Technical Service Information

THM 440-T4 SLIPPING AND/OR NO TCC APPLY

Figure 2

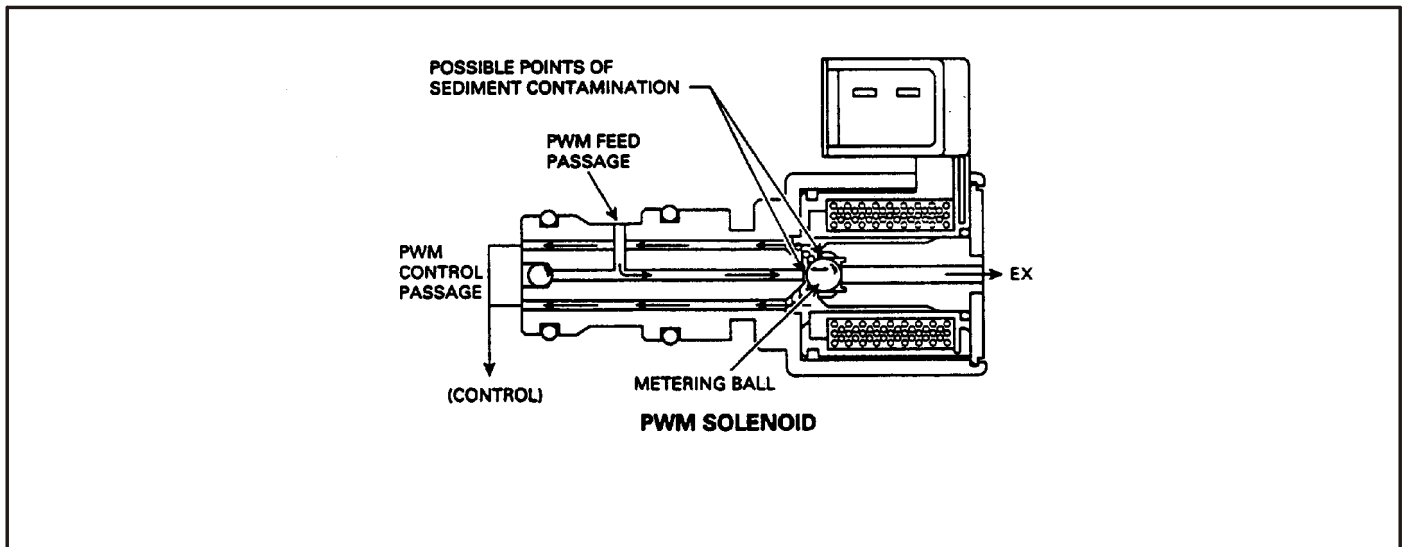
CAUSE: The cause may be due to sediment trapped in the PWM solenoid, and may enter the solenoid from either the control and/or feed passages and lodge in the flow path around the metering ball causing an undesired leak (See Figure 2).

Figure 3

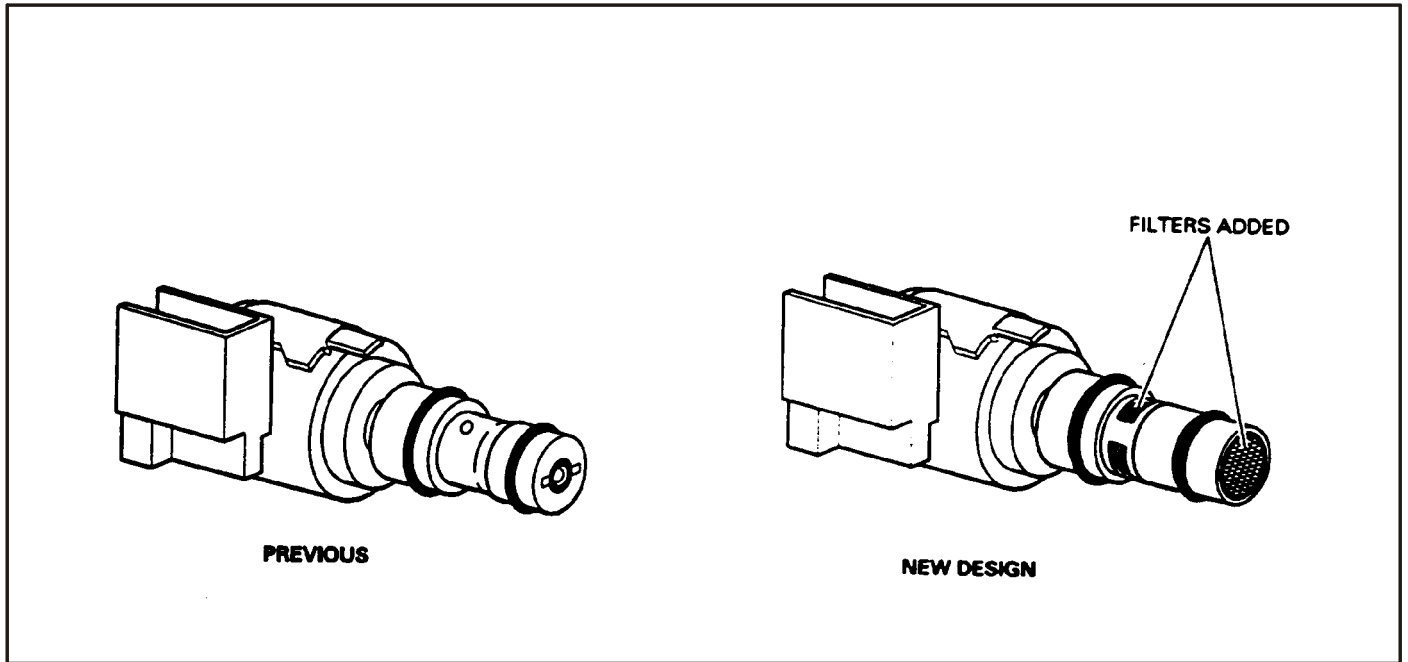
CORRECTION: Replace the Pulse Width Modulated (PWM) Solenoid with OEM part number 8683535. This is the new design solenoid, in which screens were added to the solenoid control and feed passages (See Figure 3). The PWM spacer plate filter has also been eliminated on the later models that use the new design PWM solenoid (See Figure 4). The new design PWM solenoid with screens added should be installed on all rebuilds to prevent contamination. It is not necessary to remove spacer plate filter when installing the upgraded PWM solenoid.

Pulse Width Modulated (PWM) Solenoid Assembly 8683535
(New Design With Added Screens)
